BID ADDENDUM NO. 1

February 12, 2026
Elmira City School District
EHS 2025 Capital Improvements
2012-242

SED #07-06-00-01-0-016-027 – High School

The following Addendum items shall be considered a part of the contract documents prepared by HUNT ENGINEERS, ARCHITECTS, LAND SURVEYORS & LANDSCAPE ARCHITECT, DPC. dated November 25, 2025 and issued for bids on January 27, 2026.

CANOPY SECTION

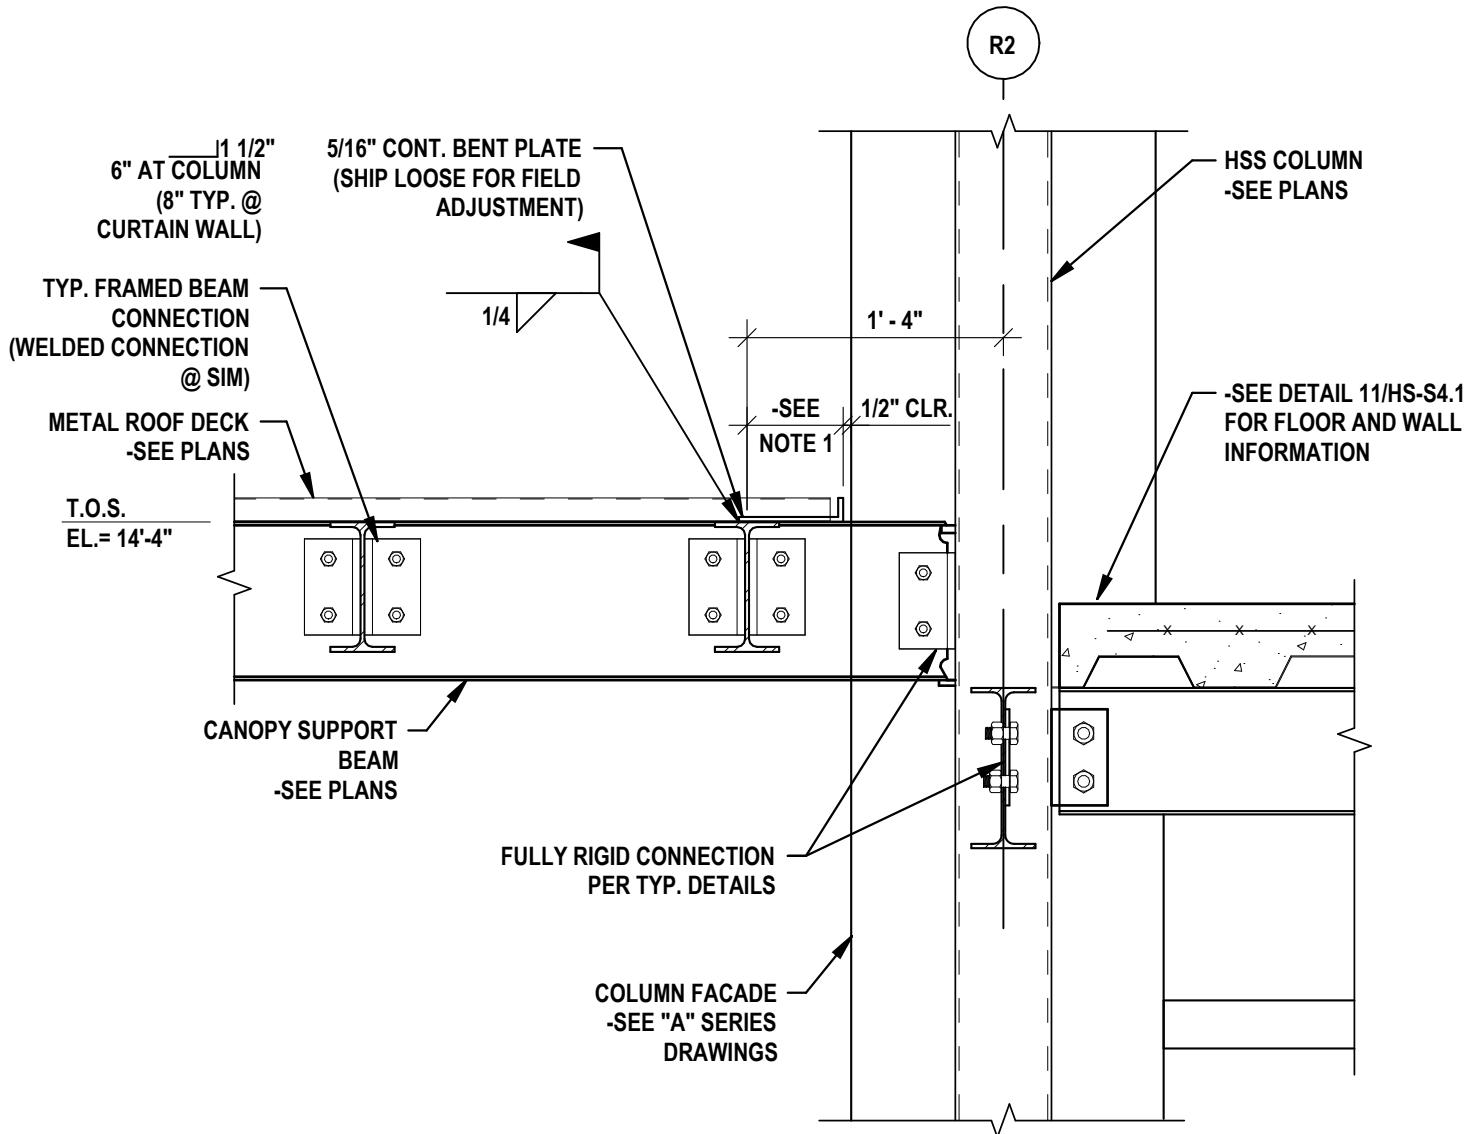
AMEND Detail 12/HS-S4.1 per detail 12/AD1-S1 as issued with this addendum.

-AMEND DETAIL 12 ON SHEET S4.1

1. DIMENSION SHALL BE 6" AT COLUMN, AND 7 1/2" AT CURTAIN WALL(TYPICAL).
